# Land at Little Bushey Lane, Bushey

Rebuttal Flood Risk Proof of Evidence

**APPEAL REFERENCE: APP/N1920/W/23/3314268 - Land East Of Little Bushey Lane And North Of The Squirrels**

**LPA REFERENCE: 22/1071/OUT**

**Figure 2.1 Thames Water Sewer extract (see Appendix A for full record)**

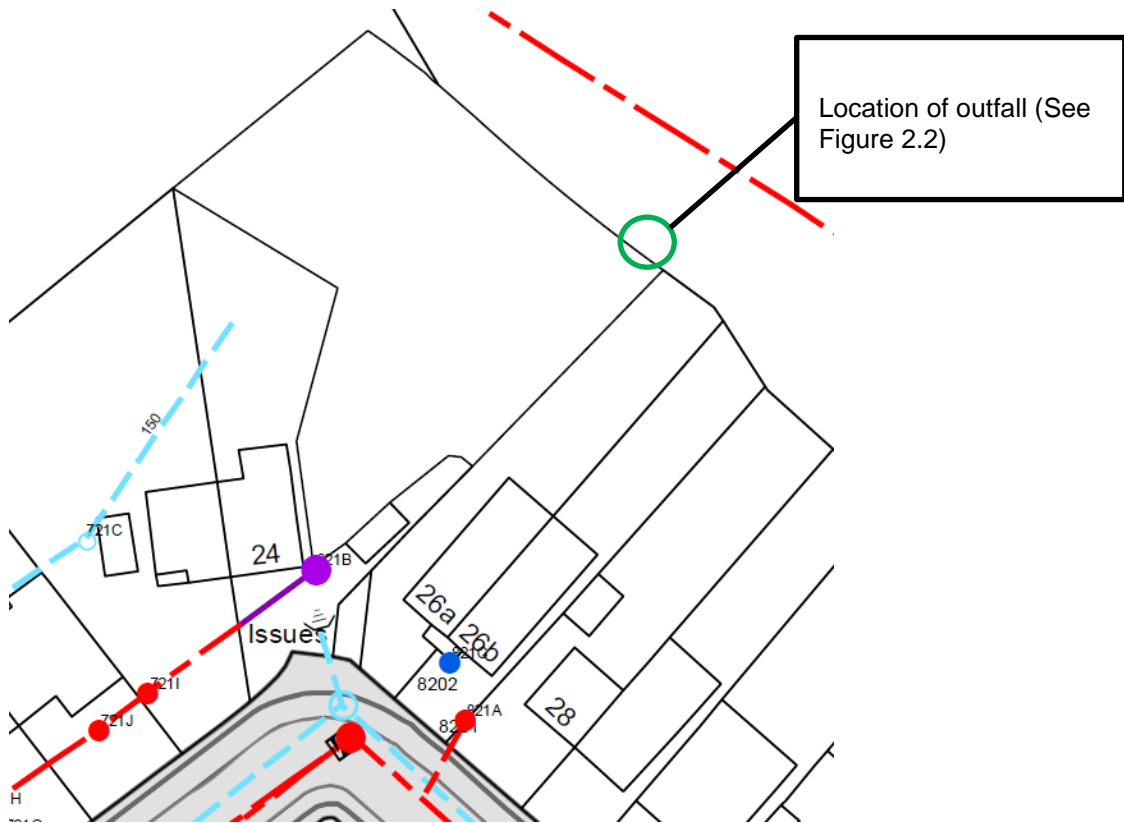
- 2.5 With regard to the Thames Water surface water sewer shown to discharge to the rear of No. 24 Wayside Avenue, the LLFA note that the sewer records 'clearly show a Thames Water surface outfall discharging to the watercourse from the upstream urban residential area' (**Appendix A**). This is incorrect as the records do not show a connection to a watercourse (**Figure 2.1**). This is a private property and the point of discharge has not been confirmed, however a small 150mm diameter pipe was seen discharging to the site from the rear fence of this property during a site inspection (Figure 2.2). Notwithstanding this point, the flow from this 150mm outfall has been considered in the hydraulic model with the rainfall from the contributing catchment being accounted for in the model and the location of the proposed swale to collect and convey this flow being located to account for this. The swale utilised in the model has sufficient capacity to convey the flow from the upstream catchment, including the flow from this outfall pipe.

Figure 2.4 LiDAR vs Topo – section 2

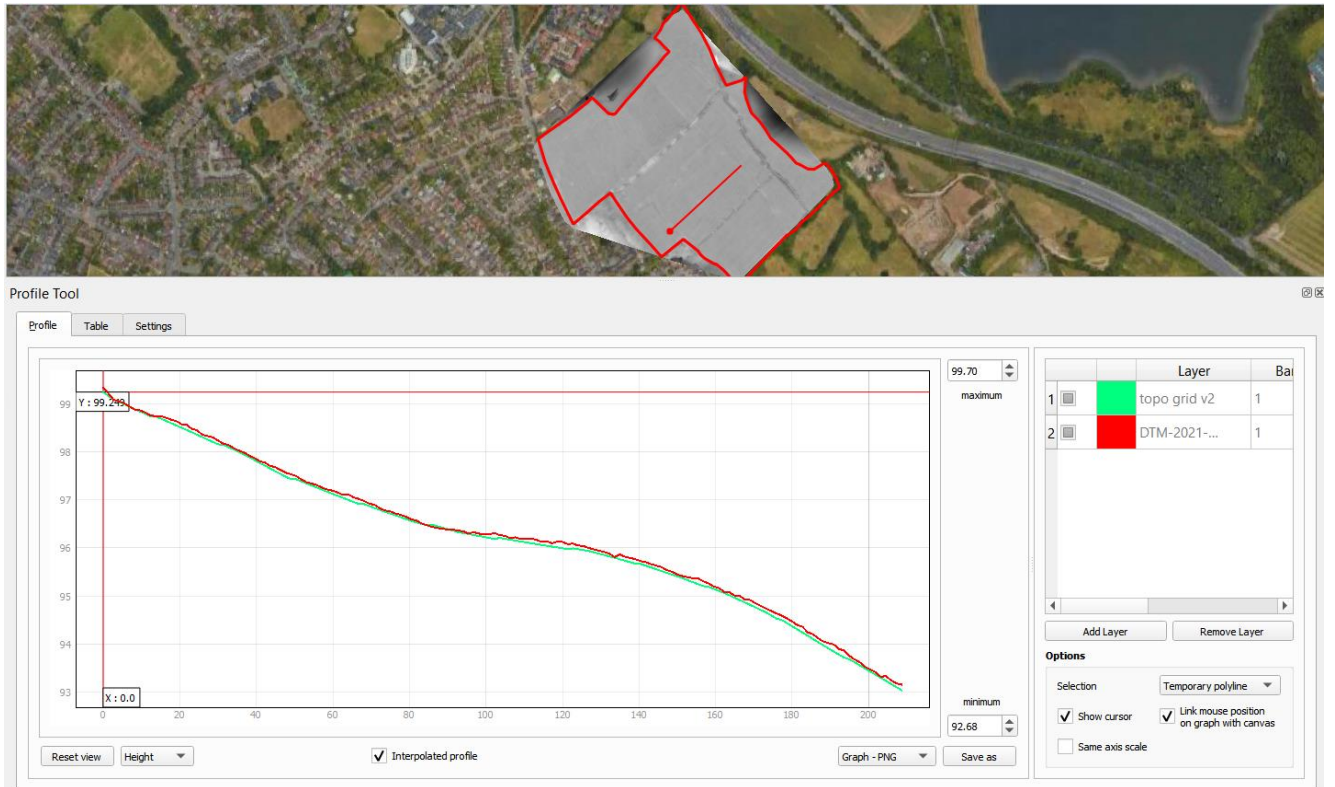
- 2.9 The ground levels data used is based on LiDAR as stated in the submitted FRA, Core Document D7, this allows for the whole catchment to be reasonably represented in the model. A comparison between the LiDAR and the levels based on a triangulated topographic survey for the site show the LiDAR used and the topographic survey data to be comparable and suitable for use (**Figure 2.3 – 2.5**). These figures show how the LiDAR ground levels and the topographic ground levels data are a suitable fit with no significant variation in the 2 datasets, as such the use of LiDAR for the site and catchment wide modelling is suitable and fit for purpose.
